ADDENDUM No. SEVEN (7)

IFB No. 2021-239

CONSTRUCTION, COLLIN COUNTY ADULT DETENTION FACILITY, PHASE 1 ADDITION

DATE: SEPTEMBER 1, 2021

LEVEL 1 EAST - REFLECTED CEILING PLAN

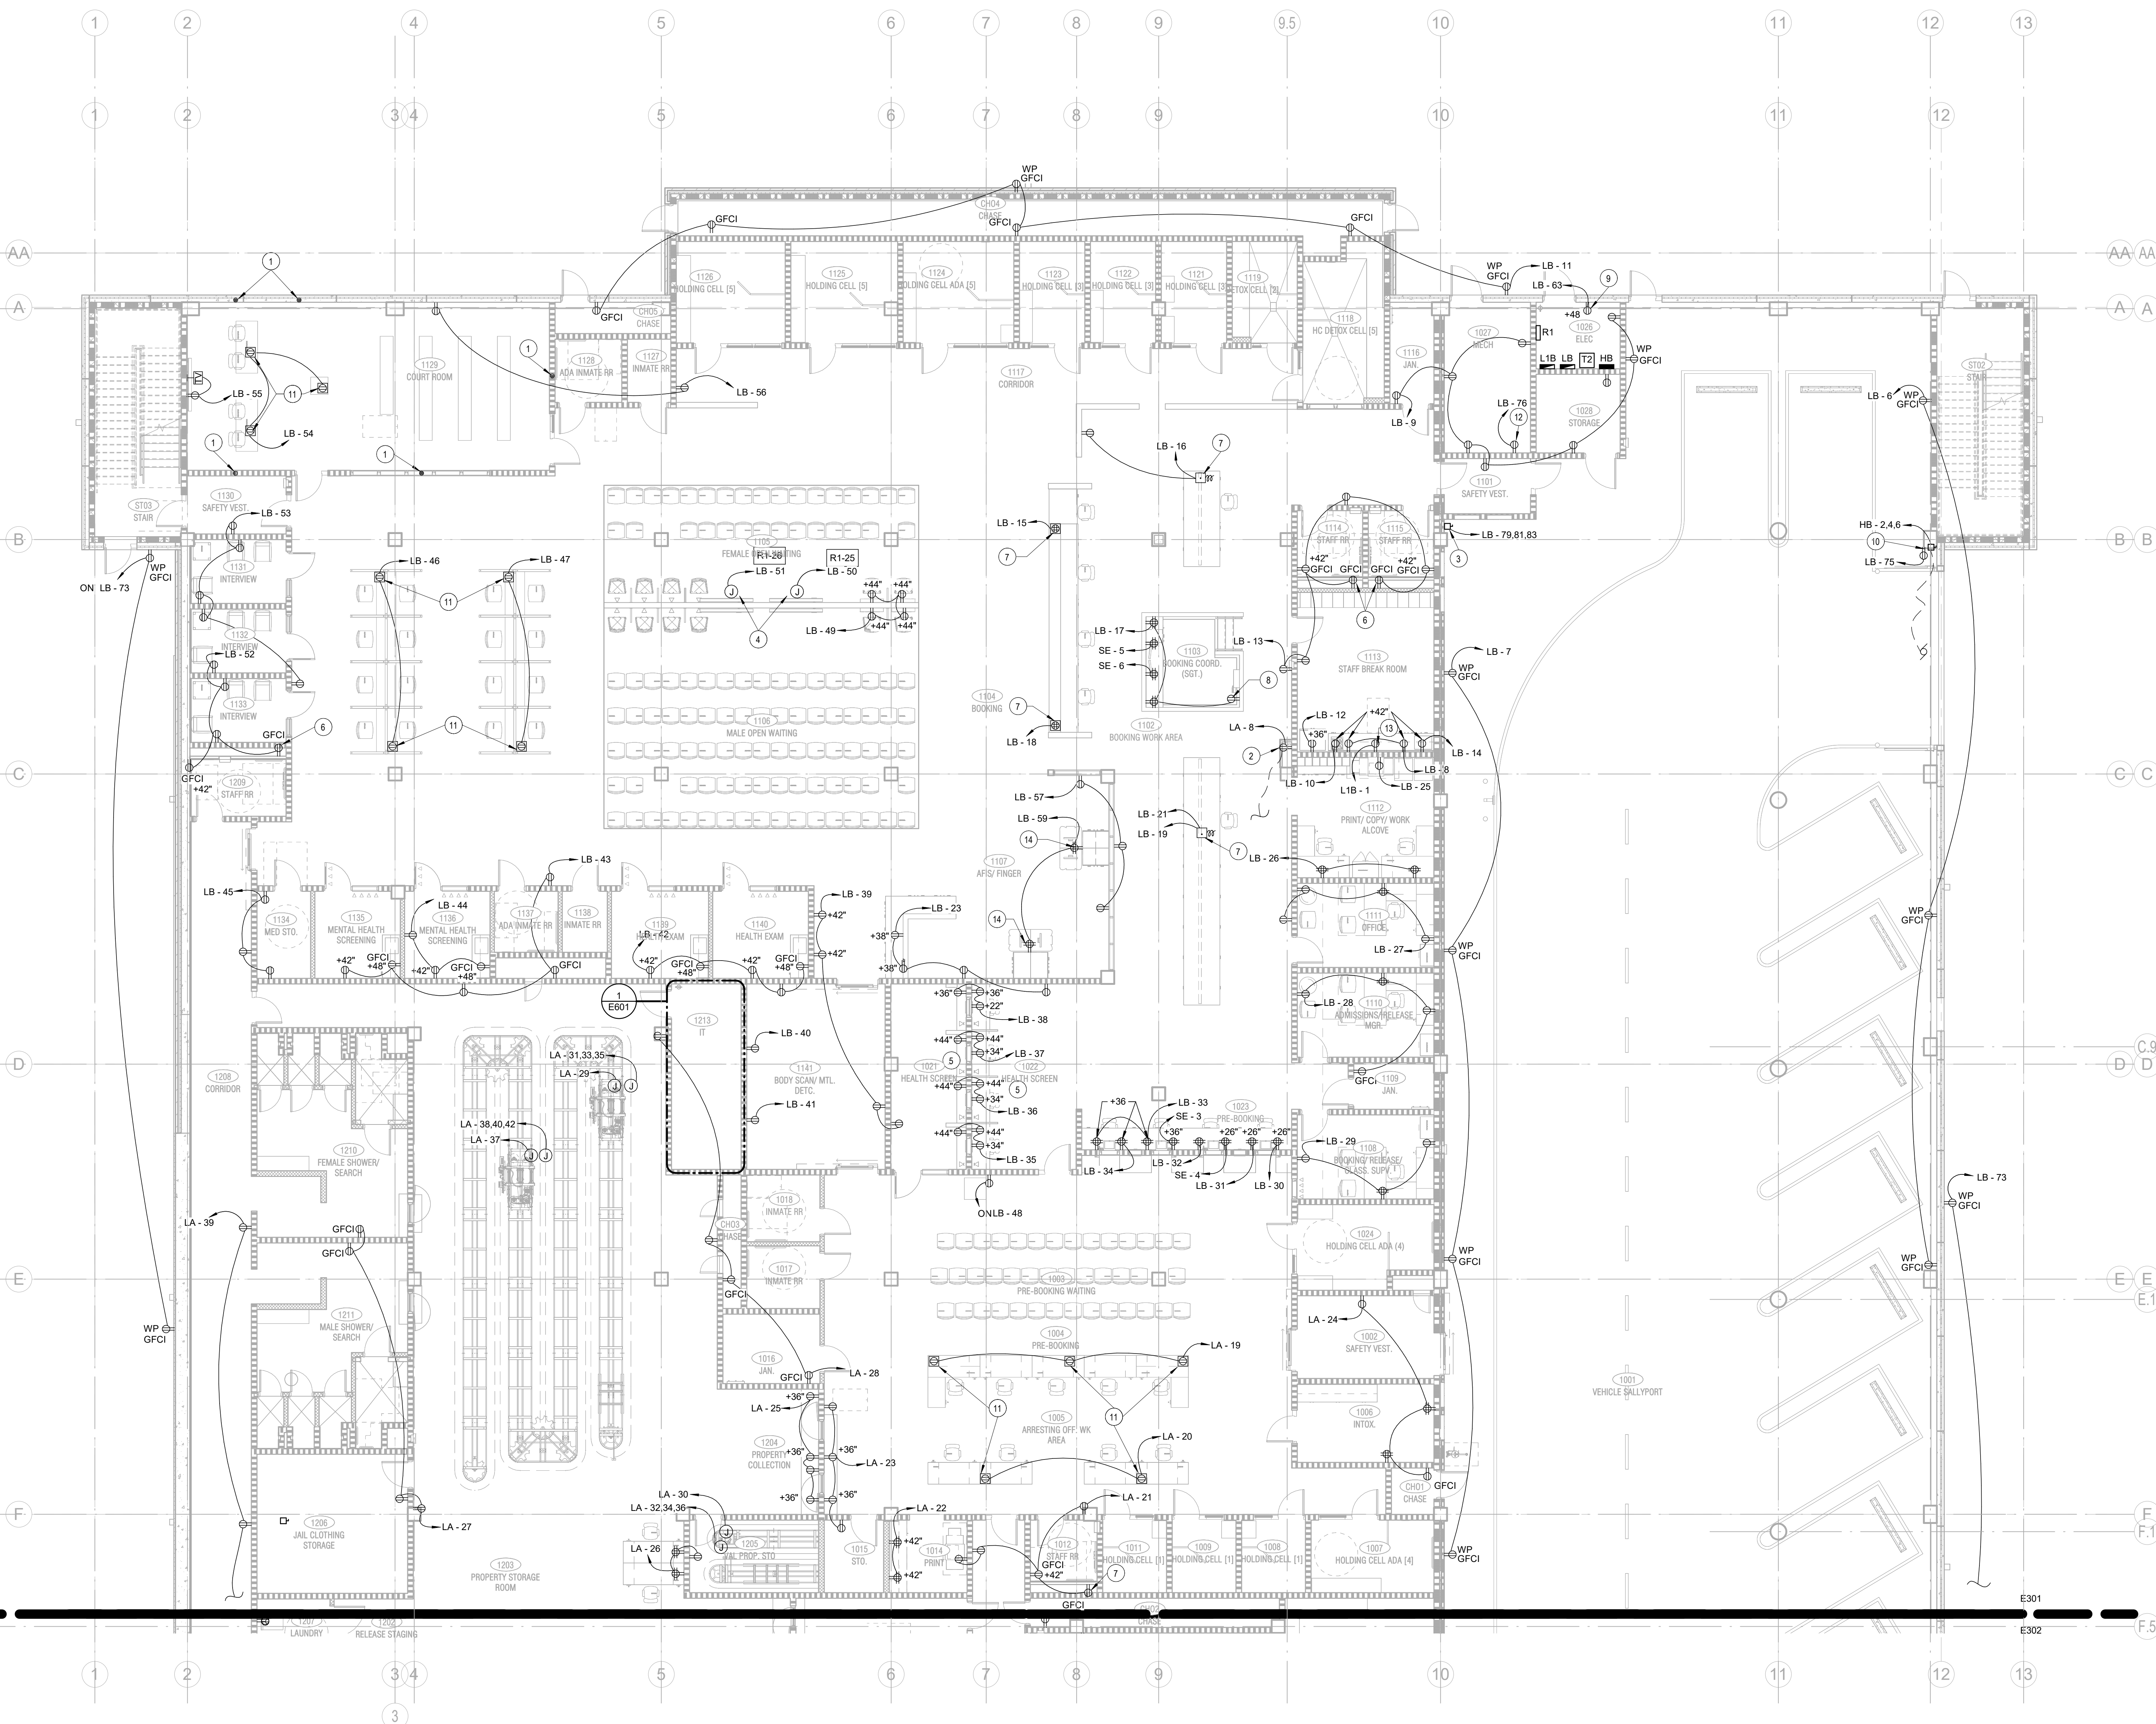
- Item No. 4. Sheet – CVR**
 - A. Updated sheet index.
- Item No. 5. Sheet – A303**
 - A. Updated reflected ceiling plan.
- Item No. 6. Sheet – M201**
 - A. Updated note.
- Item No. 7. Sheet – M202**
 - A. Updated note.
- Item No. 8. Sheet – E301**
 - A. Added note.
- Item No. 9. Sheet – E302**
 - A. Added note.
